Report No. CHAINVALLEY04/01

SUBJECT: Independent Peer Review of Subsidence and Impact Assessment Undertaken by Ditton Geotechnical Services Pty Ltd: Chain Valley to Mannering Colliery Connection Roadways

FIGURE 3. Measured Time Dependent Subsidence Behaviour above Comparable GN Seam Workings (Reproduced Figure 8b from DGS 2014)

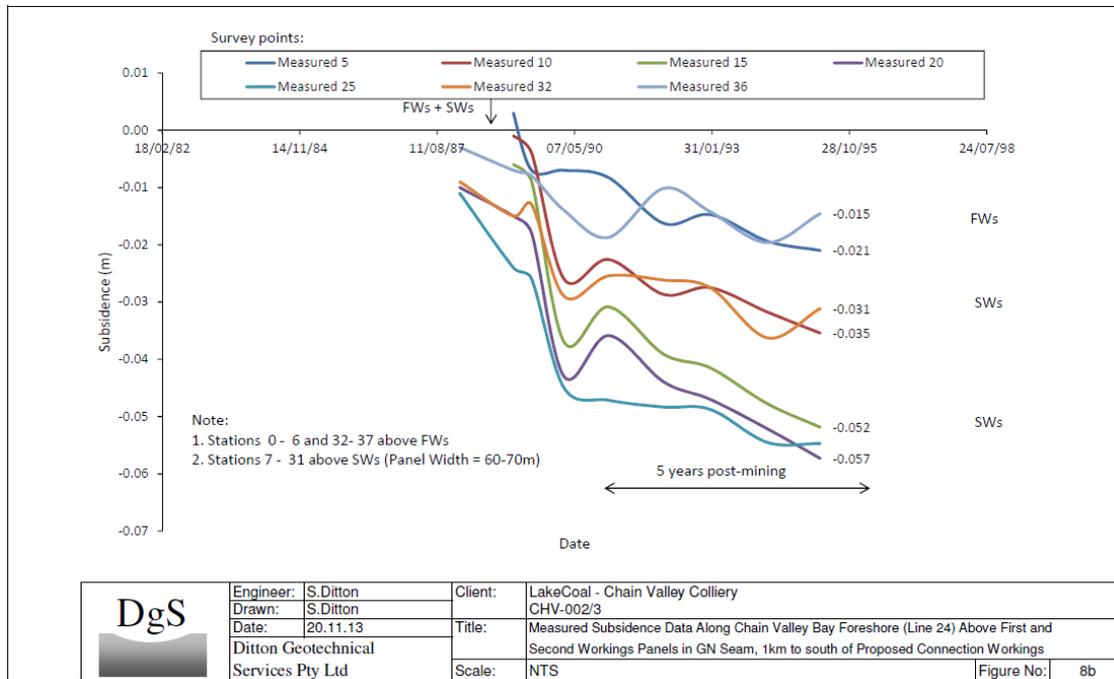
- (iii) A significant effort has been made to provide rational and logical explanation for previous unexpected surface subsidence "events" in the general vicinity, these relating to the time-dependent behaviour of soft floor measures directly beneath Great Northern Seam workings. Offering a credible explanation for measured time-dependent subsidence behaviour (see **Figure 3** as an example) that when it was occurring resulted in significant cause for concern as to long-term outcomes, is a significant contribution to the DGS impact assessment, particularly as it has been linked to a well-established

aspect of claystone stability under vertical loading, namely the exceedance of pre-consolidation pressures resulting in primary and secondary consolidation over time.

FIGURE 4. Predicted Subsidence Isopachs Due to the Formation of the Connection Headings in the Fassifern Seam and Surface Features (Reproduced Figure 18b from DGS 2014)

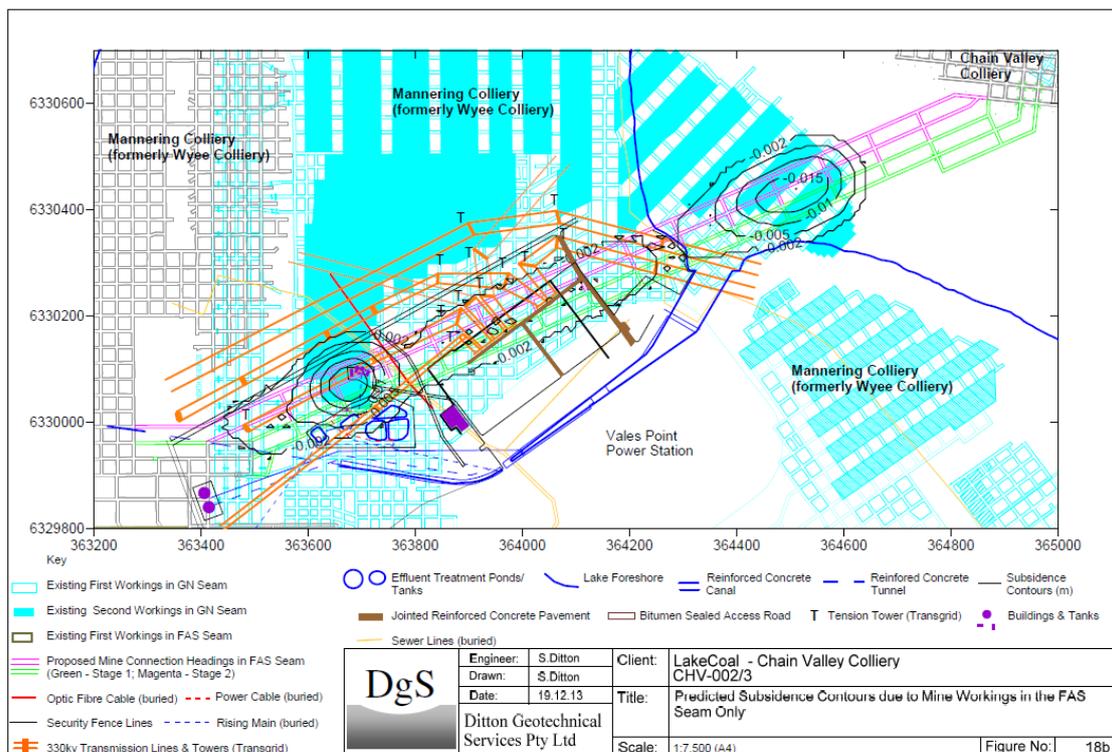
Figure 4 shows isopachs of the increase in surface subsidence as a direct result of forming the proposed connection headings along with the various surface features that are of relevance. This figure along with those detailing tilts, curvatures and strain provide a credible basis for assessing the likely impact on the various defined surface features due to the formation of the Fassifern Seam connection headings.

The areas of pre-existing second workings in the Great Northern Seam are logically where the highest level of additional surface subsidence has been predicted due to the formation of the connection headings. Up to 25 mm of additional vertical lowering is predicted in these areas, albeit that the lake foreshore is limited to in the order of 2 mm of additional lowering due to the Great Northern Seam workings having been restricted to first workings directly under the foreshore.

The TransGrid infrastructure of the Vales Point sub-station and nearby transmission towers (some of which are known to be tension towers) is situated above first workings in the Great Northern Seam such that the predicted increase in vertical subsidence as a result of forming up the proposed connection headings in the Fassifern Seam is 6 mm and less, again noting the conservative assumptions used by DGS when calculating these values. The associated maximum values of curvature, tilt and strain are $< 0.03 \text{ km}^{-1}$, $< 0.2 \text{ mm/m}$ and $< 0.3 \text{ mm/m}$ respectively. **Figure 4** also indicates that the majority of the TransGrid tension towers are located outside the 2 mm additional surface lowering isopachs so will be influenced by $< 2 \text{ mm}$ of vertical lowering due to the proposed mining.

Overall, it is judged that the vertical subsidence predictions provided by **DGS 2014** are at the absolute low end of what can be considered as "meaningful predictions" in that any lower values would almost certainly lead to a conclusion of "zero" subsidence. It is considered that the various predictions as they relate to TransGrid infrastructure can be classified as "imperceptible" levels of increased surface subsidence as it is likely that they will result in no obvious visible changes to surface conditions and may not even be detectable using survey methods (dependent upon local near-surface strata conditions).
